# UNITED STATES PATENT AND TRADEMARK OFFICE

APPLICATION NO.	FILING DATE	FIRST NAMED INVENTOR	ATTORNEY DOCKET NO.	CONFIRMATION NO.
10/033,161	10/26/2001	Jack V. Rice	1031.111	7142

**Office Action Summary**

## DETAILED ACTION

FIG. 2

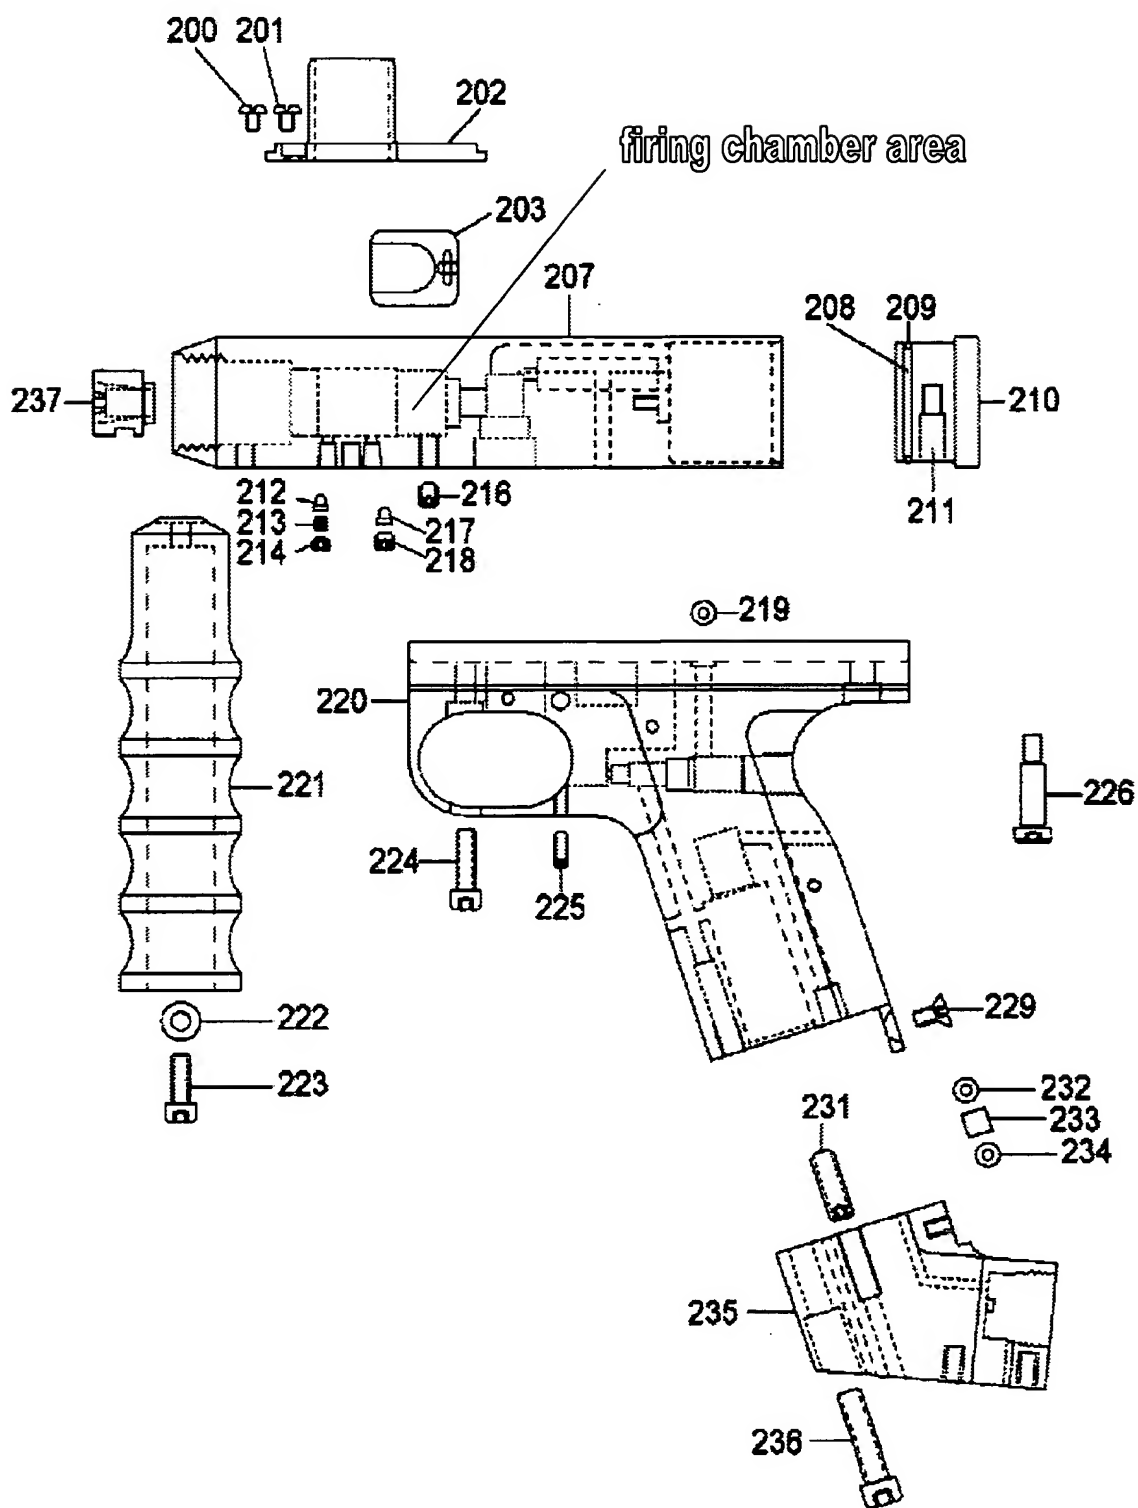
The Examiner agrees with the applicant insofar as there is an admission that the firing chamber disclosed by Reible is shown as being located to the left of the diffuser. As shown below in Fig. 2, the diffuser 237 is to be located in an unnumbered passage

within body 207. The unnumbered passage (labeled 'firing chamber area' by the Examiner) extends to the left to include a threaded area for attaching a barrel as agreed by the applicant. However, Fig. 13 shows us that the firing chamber is further defined by the storage cavity 307 as well as the passage leading from the storage cavity 307 to the area defined by the location of the diffuser and paintball. Referring to Fig. 12, when the storage cavity 307 is fully charged a piston 506 operates to seal the passageway between the storage cavity 307 and the area occupied by the diffuser. But, in Fig. 13, the piston 506 is retracted and the entire area defined by the cross-hatchings becomes the firing chamber.
